SONY

Model: PVM-14N1U/14N2U/20N1U/20N2U

Video Products Technical Bulletin 1996-165R

Subject: BKM-104 BOARD INSTALLATION

Figure 1

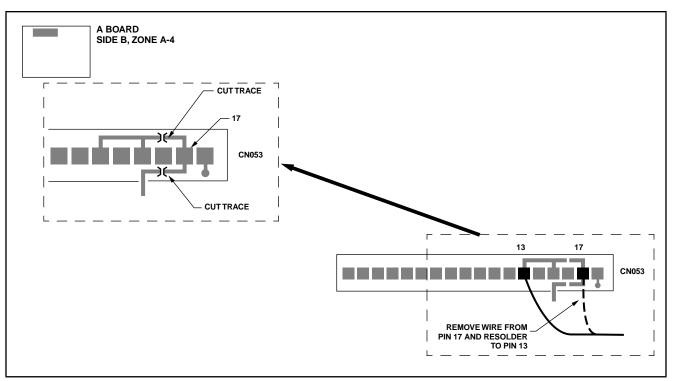
After the BKM-104 caption vision board is installed, CAPTION VISION and the OSD may not display. Due to boards and pin assignments being changed, a short circuit may develop between the display timing signal and ground.

- 1. Remove rear cabinet cover.
- 2. Remove wire soldered to CN053 pin 17 (zone A-4, side B). (See Figure 1.)
- Remove resist and silk print from around CN053 pin 17. Cut traces.
- 4. Solder removed wire, from CN053 pin 17 (step 2), to CN053 pin 13 as shown in Figure 1.
- 5. Remove JW185 and replace with 1SS133 diode. Solder diode, connecting cathode to IC301 side. (See Figure 2.)
- 6. Replace R318 (10k Ω) with 2.2k Ω resistor.
- 7. Solder 250mm wire jumper between the 1SS133 cathode and CN053 pin 17.

NOTE: Route jumper along board edge.
